Kent

December 2023

12. What do you think about our proposed landfall at Pegwell Bay?

13. What do you think about our proposed HVDC cable route in Kent?

Sealink Order Limit against CPRE Dark Sky Map

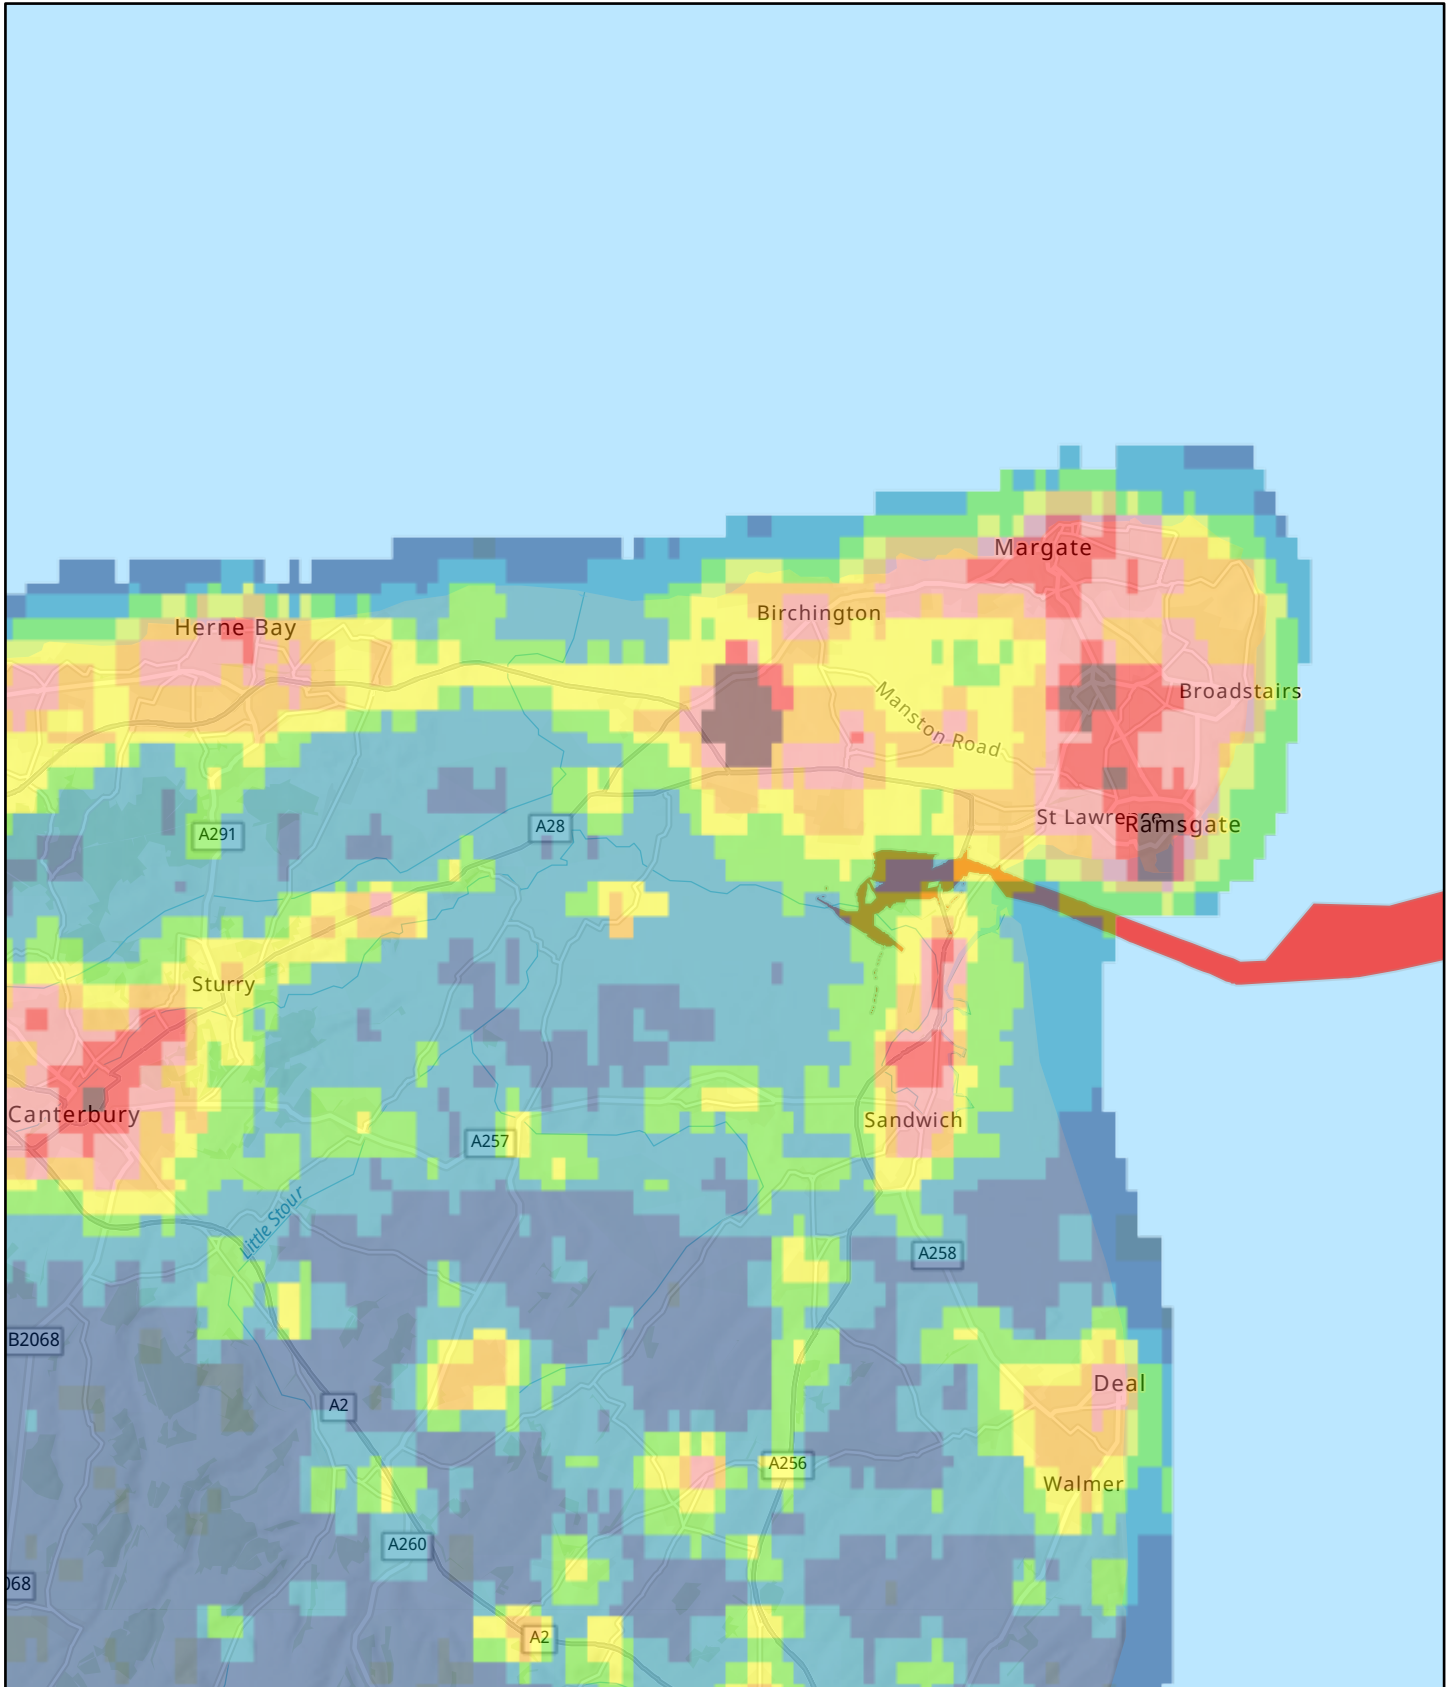
The proposed location is within one of the few remaining areas of darker skies within the Thanet District as shown within CPRE Dark Sky mapping (appended below). It is therefore deeply concerning that this very significant constraint has been given little to no consideration within the various PEIRs.
